Well Name: POKER LAKE UNIT 13 DTD

Well Number: 115H

Notice of Intent

Type of Action: APD Change

WELL LOCATION AND ACREAGE DEDICATION PLAT

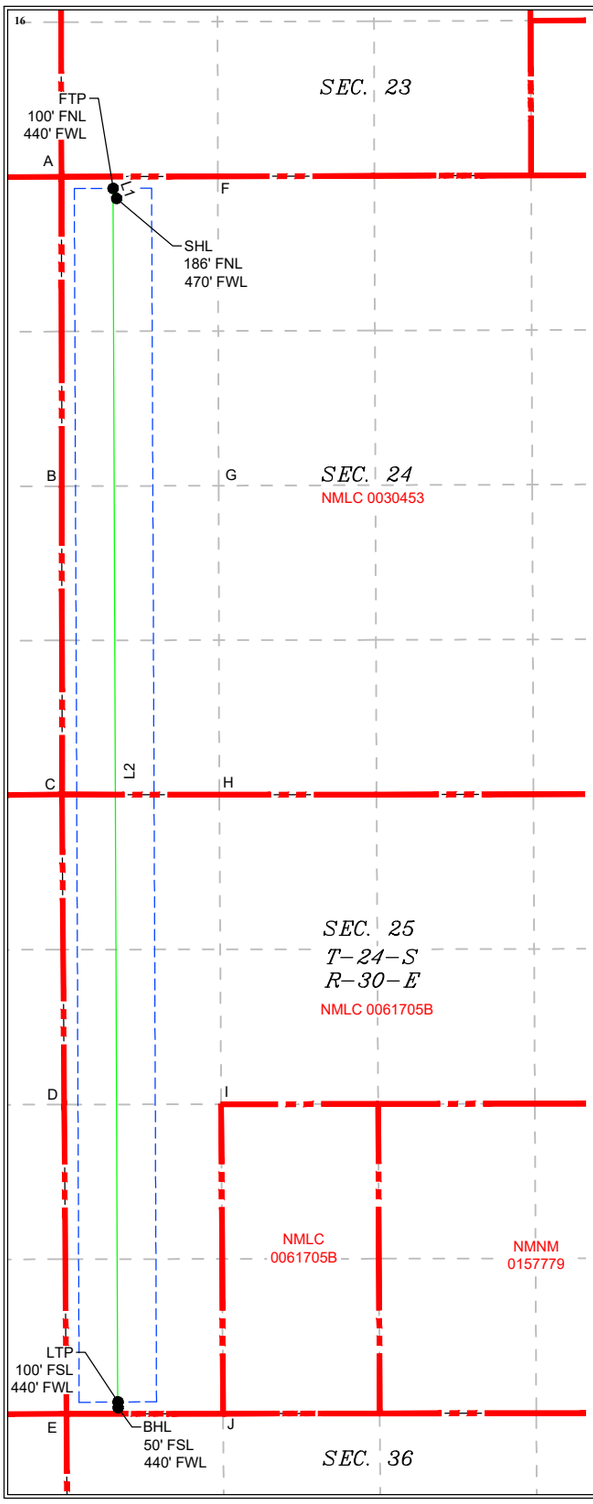
SHL: fr/186FNL & 505FWL to 186FNL & 470FWL, Section 24-T24S-R30E

FTP: fr/100FNL & 330FWL to 100FNL & 440FWL

LTP: fr/100FSL & 330FWL to 100FSL & 440FWL

BHL: fr/50FSL & 330FWL to 50FSL & 440FWL, Section 25-T24S-R30E

UL or lot no.	Section	Township	Range	Lot Idn	Feet from the	North/South line	Feet from the	East/West line	County
D	24	24S	30E		186	NORTH	470	WEST	EDDY

UL or lot no.	Section	Township	Range	Lot Idn	Feet from the	North/South line	Feet from the	East/West line	County
M	25	24S	30E		50	SOUTH	440	WEST	EDDY
